CABINET MEMBER FOR TRANSPORT MANAGEMENT 25 JANUARY 2024

OXFORD: A4144 WOODSTOCK ROAD – PROPOSED SHARED USE CYCLE TRACK

Report by Corporate Director, Environment and Place

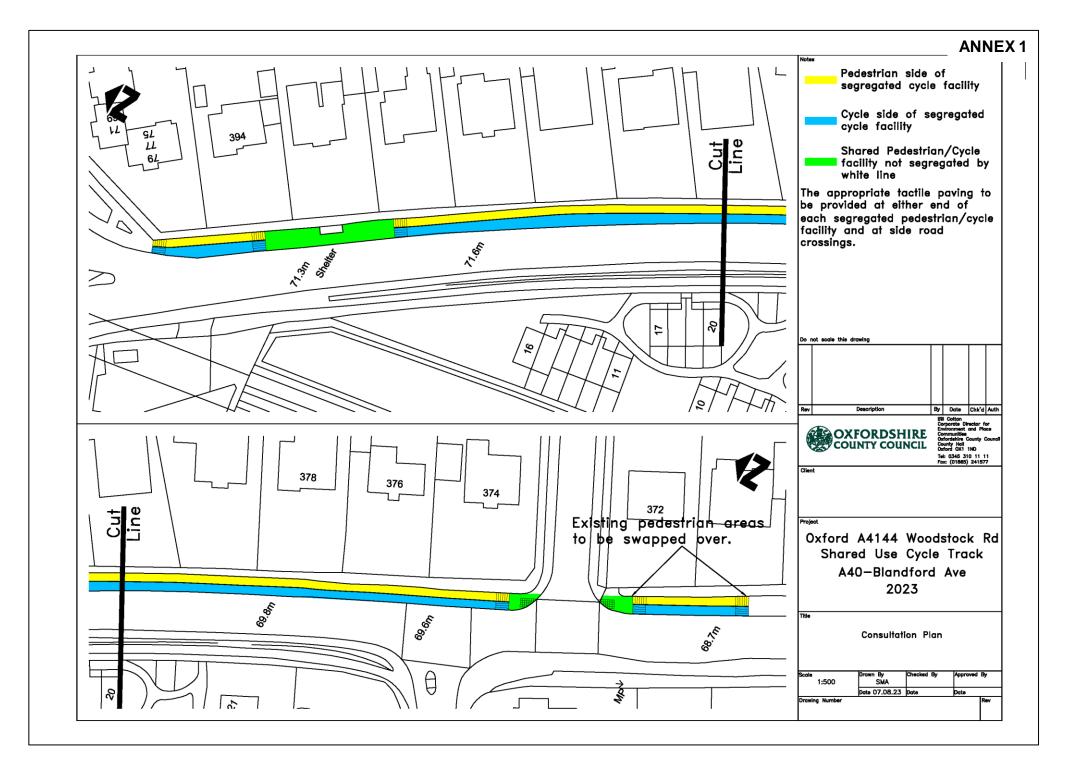
RESPONDENT	COMMENTS
(1) Traffic Management Officer, (Thames Valley Police)	No objection
(2) Local group/organisation, (Cyclox)	Concerns – 1. We would like to mention that there was no coproduction with this scheme which we find very disappointing. The plans provided with it are poor quality, and in particular don't show the widths of the proposed cycle track or whether the cycle track will be separated from the footway by a half-height kerb or just by a painted line.

2. Our own measurements suggest sections of the current footway are well under three metres wide. This does not allow for adequate (LTN 1/201 compliant) separated foot and cycle paths. In practice a space of this width will be used as shared space regardless of how it is marked people will want to cycle away from the motor traffic, so will use the "pedestrian" space, and people wanting to walk side-by-side will use the "cycle" space. It is better to mark this as shared space. Note also that with 30mph traffic, LTN 1/20 requires a 0.5 metre buffer between the carriageway and any a cycle track.

3. The southbound bus stop shown on the plan is likely to have to be moved to the south, since without a separate bus lane buses stopping there will back traffic up into the roundabout.

4. The cycle track needs to be continuous across the Blandford Avenue side entry, with clear priority. And the turning radii there should be tightened, to reduce vehicle speeds. Otherwise people cycling will be at risk from traffic turning in, potentially at 30mph given the large current radii whether they take a gamble and cross at speed or come to a stop and then have to get across from a standing start.

The bus stop outside Nos 392 and 394 Woodstock Road should be moved about 50 metres to the south. The southbound bus lane should start about 50 metres further south than it does at present. That would affect the positioning of the tactile paving and the markings in the currently proposed scheme.
	The two-lane northbound approach to the Wolvercote Roundabout entry could then be extended by about 50 metres. That would increase the number of cars that could queue side-by side in the two lanes by 7, ie from 6 as at present to 13.
	At present, when the traffic lights for the entry to the roundabout turn to green, cars enter the roundabout two abreast for, at the most, the first six cars in each lane. For the majority of the green time, the cars enter the roundabout one at a time. Often, when the queue in the offside lane becomes seven cars long, there are only 3 or 4 cars in the nearside lane, and no more can get past the offside lane queue to take up the vacant space in the nearside lane. When that happens, only the first 3 or 4 in each lane enter the roundabout two abreast. Then, in the remainder of the green period, 9 or 10 enter in single file. That is a terrible waste of capacity!

• The pavement is far too narrow at this point to be shared-use (OxPA holds that to encourage walking and wheeling as forms of urban transport space needs to be allowed that gives two wheelchair users room to pass one another in safety and dignity).

(5) Local group/organisation, (Oxford Pedestrians Association)	Object – Oxford Pedestrians Association is AGAINST narrowing footways to under 2m - this deters pedestrians and wheelchair users, and encourages cyclists to cycle on footways.

(6) Local resident, (Oxford, Stratfield Road)	Object – There is insufficient width for separate cycle track and footway. LTN 1/20 wants 2m for a cycle track (with 1.5m acceptable at pinch points) and a 0.5m buffer from 30mph motor traffic. Regardless of the designation of the space, people cycling will use the full width available (including the pedestrian area) to avoid cycling right next to motor traffic, and to overtake one another, while people walking will use the cycle space if they want to walk two abreast. It is better - especially for the visually impaired - to mark the space to reflect how it will actually be used. The cycle (or the foot-cycle) path needs to be continuous across the Blandford Avenue side entry. The crossings should remain level, with motor traffic forced to slow down by having to negotiate steep ramps, and the corners on the entry should be tightened to further slow motor traffic.

- 18. The proposal will address a current gap in the provision for cyclists on the east side of the Woodstock Road between the A40 Wolvercote roundabout and the Blandford Avenue junction. The typical dimensions available for pedestrians and cyclists will match (in respect of its width and presence of driveways etc.) the existing provision on both the east and west sides of the road which was originally provided in 1993 and which has served as a well-used amenity of particular benefit to less confident cyclists. If approved, as part of the scheme cutting back of vegetation that has encroached onto and over the highway will be carried out, noting that adjacent landowners also have a duty to ensure that vegetation within their land does not obstruct the highway.

- 19. While very much acknowledging that national design guidance on cycle provision (Local Transport Note 1/20) states that shared use cycle tracks of this type are not the preferred approach to providing new cycle infrastructure, this guidance nevertheless acknowledges that where other types of provision may not be viable, shared use cycle tracks can be of value. In putting forward the

proposals, officers have taken account of the significant constraints applying to the Woodstock Road as a key route for buses and active travel and consider that at present the scope for providing other forms of cycle provision is not likely to be viable at least in the shorter term, and that as a relatively low cost scheme , the current proposal is appropriate and will support the Council's transport objectives notwithstanding the recognised departures from current standards.

- 20. The suggestion made by Cyclox for a shared pedestrian / cycle space to be provided in place of a white line segregated provision as currently shown (excepting at the bus stop) is noted and will be investigated taking account of the improvement to the available width following the vegetation clearance works referred to above. It is also agreed that the provision of a continuous cycle track across Blandford Avenue with cycle priority is desirable and although outside the scope of the current scheme, will be investigated as part of wider works as described below.

- 21. The suggestion for relocating the southbound bus lane and extending the two-lane northbound approach to the Wolvercote roundabout is acknowledged. The potential for improvements to northbound bus journey times and reliability are noted however the proposals however sit outside of the scope of this immediate project. It should however be noted that the county council has identified funding to review both bus lane and wider active travel provision on the Woodstock Road, an identified complementary measure for the planned traffic filter trial. The proposal has been shared with the project team developing this piece of work for consideration.
